UNITED STATES PATENT AND TRADEMARK OFFICE

| APPLICATION NO. | FILING DATE | FIRST NAMED INVENTOR | ATTORNEY DOCKET NO. | CONFIRMATION NO. |
|-----------------|-------------|----------------------|---------------------|------------------|
| 10/826,311 | 04/19/2004 | Thorsten Stabel | 47481-0008-00-US | 1320 |

| Office Action Summary | Application No. 10/826,311 | Applicant(s) STABEL ET AL. | |

DETAILED ACTION

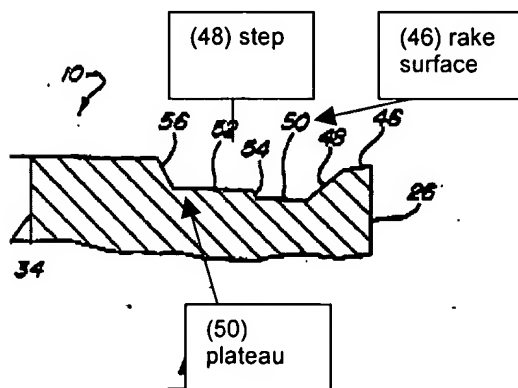
linear when viewed perpendicular to the cutting surface). Additionally, Katbi et al. teaches side flanks forming obtuse corners (see figure 2). Katbi et al. also teaches in figure 3, lateral cutting edge (38) having a sagging middle portion therefore the step is of varying height having a maximum height is disposed at the corner step portions and a minimum height midway between the adjacent corners (refer to the explanation and figure below regarding the varying height of the step: see argument under Response to Arguments). Regarding claim 19, Katbi et al. teaches variable width land surface (rake) which is changes width at (44) leading to a wavy step portion around the corners (see figure 2 and Col. 2, lines 49-54). Furthermore, Examiner points out that Katbi et al. teaches the cutting edge (38: which is arched) has a descending rake (46) located rearward from the cutting edge and the descending rake face is followed by a descending step (48) ('591, figure 4 and Col. 2, lines 45-58 and 66-68). If the height of the step was constant then the step would no longer be descending towards the center of the insert but rather ascending since the rake surface just forward of it has a variable descending angle. See figure below for further explanation (the angles are exaggerated). Katbi et al. teaches the rake face (46) having descending angle 14 degrees and narrower width (wa) at the corner and 12 degrees and a wider width (wb) towards the flank ('591, Col. 2, lines 58-60 and 51-53). As shown below, the left figure indicates corner portion where the cutting edge is at it's highest height (because it's arched at the center), however the rake face has a wider descending angle and a narrower width (wa) which leads to the following portion (i.e. descending step, 48) to start descending from a higher location to plateau 50. On the other hand, the right hand

figure represents the flank area such as the center where the cutting edge is at its lowest height (because it's arched at the center), however the rake face has a smaller descending angle and a wider width (wb) which leads to the following portion (i.e. descending step, 48) to start descending from a lower location to plateau 50, thus there is a height difference (ha is higher than hb) (i.e. the step has a varying height, wherein a maximum height is disposed at the corner step portions, as recited in claim 1).

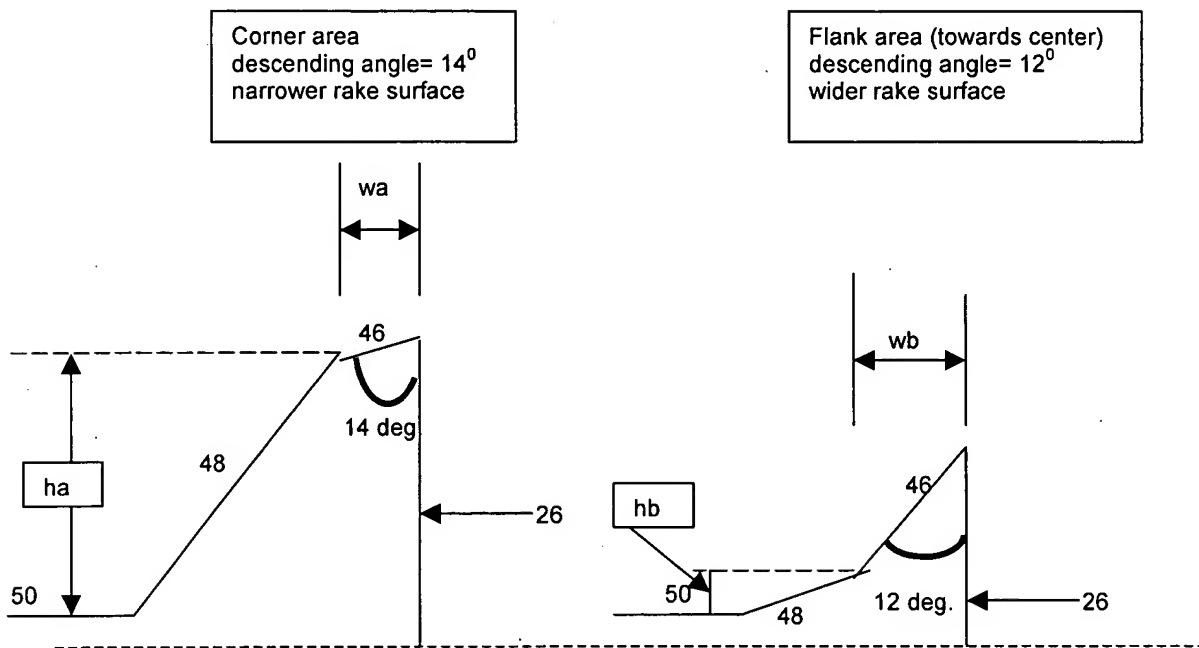
Furthermore, Katbi et al. teaches '591, Col. 2, lines 60-65) that "Those skilled in the art recognize that any angles can be used as the first variable descending land angle so long as the first variable descending land angles at the corners of the insert are greater than the first variable descending land angle of the surface along the flanks of the insert", therefore the selected angles would determine how substantially height difference there should be. Examiner points out that given the fact that inserts are small in size, even if the angle difference is small, there is a height difference which may be considered "substantial" in a unit of measure such as micrometer.

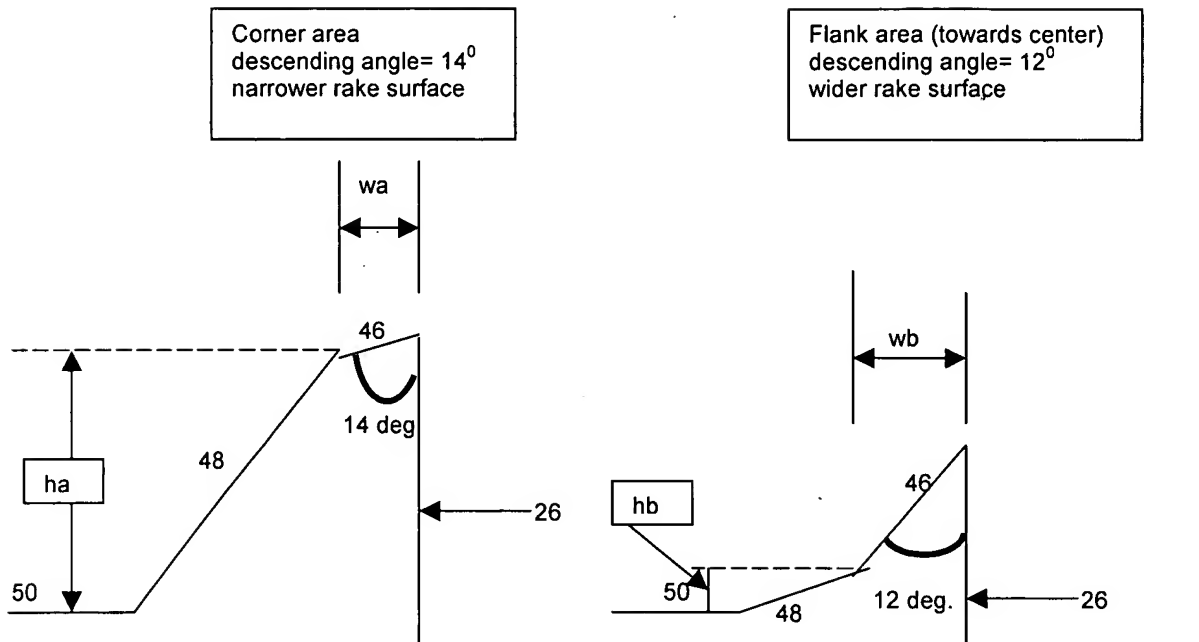
In response to Applicant's argument (page 9, lines 7-14) that "The variable descending land angle 46 is 14 degrees at each corner of the insert and merges to a 12 degree along the flank of the insert.....Applicant respectfully submit that any such variation of the height of step 48 is negligible, and in any event the height of step 48 at the corners is certainly not substantially greater in height of step 48 of the flanks". Examiner respectfully points out that Applicant has not defined what determines the limitation "substantially greater". Applicant has not provided any range to define this difference in height. Broadly reading the claim, Examiner points out that given the fact that inserts are small in size, even if the angle difference is small, there is a height difference which may be considered "substantial" in a unit of measure such as micrometer. Furthermore, Katbi et al. teaches (Col. 2, lines 60-65) that "Those skilled in the art recognize that any angles can be used as the first variable descending land angle so long as the first variable descending land angles at the corners of the insert are greater than the first variable descending land angle of the surface along the flanks of the insert".

In response to Applicant's argument (page 9, line 20 through page 10, line 2) that "...Katbi does not disclose a step. Katbi discloses a descending land angle 46 and a second descending land angle 48. As illustrated in Fig 4 of Katbi, descending land angle 46 and descending land angle 48 are ramps, rather than steps", Examiner submits that MSN Encarta defines "step" as "raised surface: a raised surface for the foot, especially in a series going up or down", therefore, the descending 46 & 48 qualify as a step.

In response to Applicant's argument (page 10, lines 14-18), that "Also the applicant disagrees with the Office Action's position that surface 50 is a completely plain and even surface. Referring to Fig 1 of Katbi, land 48 is a strip of constant width..... Obviously, surface 50 is curved the same way as are the cutting edges 30, 32 and so forth", Examiner respectfully asks Applicant where this is claimed in the instant application as well as where the Office Actions takes this position. Nonetheless, figure 4 indicates that 50 is plain and even. Even if 50 is curves the same way as the cutting edge, as stated by the Applicant, it would be curved from the plan view and not from a side view).
